Subject: CORRECTING HORIZONTAL/VERTICAL SYNC

Model: BVM-D14H1E, BVM-D14H1U BVM-D14H5E, BVM-D14H5U

DPMO00-028R

Figure 2

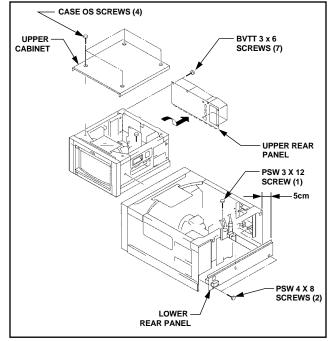
If the front edge of the G board contacts the G board bracket, a short-circuit of sync signal may occur, causing picture to lose sync.

See Figure 2.

6. Affix UL tape as shown.
